**Customer Service Bulletin**

**Subject:** CSB-BRAUN PRO4000 BATTERY PACK UPDATE

**Summary:** This Customer Service Bulletin provides detail on an updated battery pack design that reduces brown outs that lead to a lack of data transfer from the Braun PRO 4000 thermometer to a Vital Signs Device.

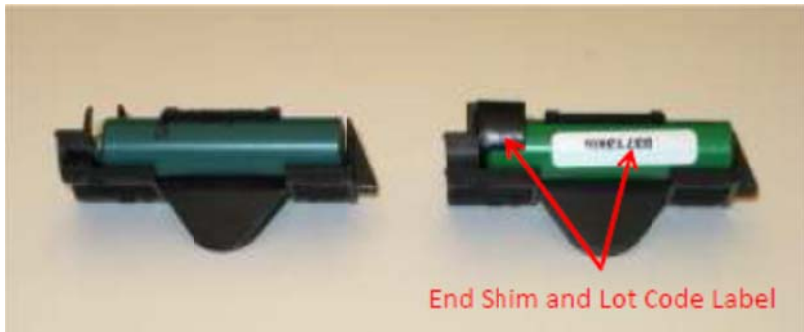
1) Customers experiencing communication transfer problems should follow the cleaning process in CSB#20012578A and visually inspect the rechargeable battery pack for determination of whether the new battery pack design is in use. The following images can be used to determine the battery pack version in use.

2) If the old battery pack design is in use and the customer is experiencing problems, they should contact Welch Allyn Technical Support for assistance. Welch Allyn customer service can contact Category Management for the product in use for approval to replace the old design with the new design at no charge under warranty. Battery pack 53020-0000 is the replacement part. The battery pack warranty period matches the warranty period of the device it was purchased with. If a customer is experiencing issues and the related device is out of warranty, a one year grace period will be allowed for warranty coverage of the battery pack.
